Staff Report

Conditional Use Permit Major Amendment / Site Plan Review: PenMet Parks Community Recreation Center

Application Numbers: 906050 / 906052 / 906054 / 906861, 909290, 909294

FIGURE 18A.15.040-2

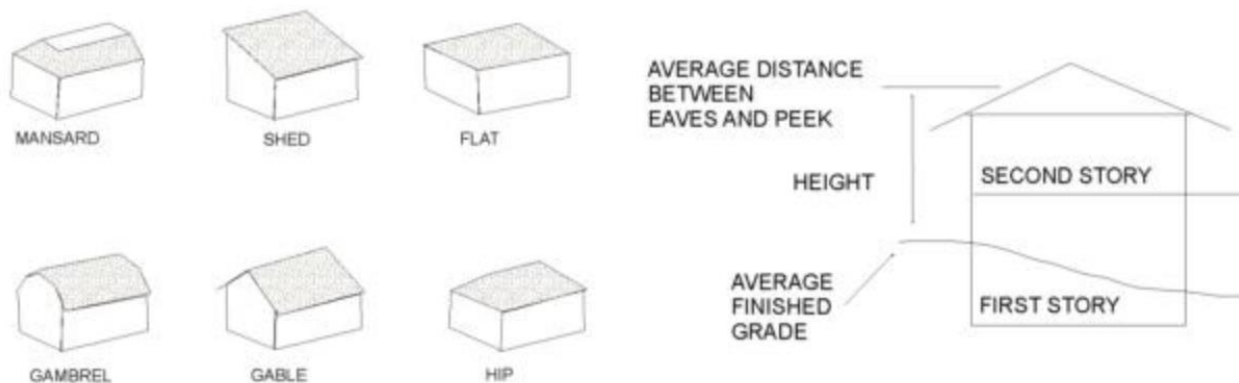
Staff Comment: The proposed building would be 84 feet tall. The Agent states that based on the definition of how the height is measured above (and the corresponding diagrams below), that the proposal comes close to meeting the height limitation.
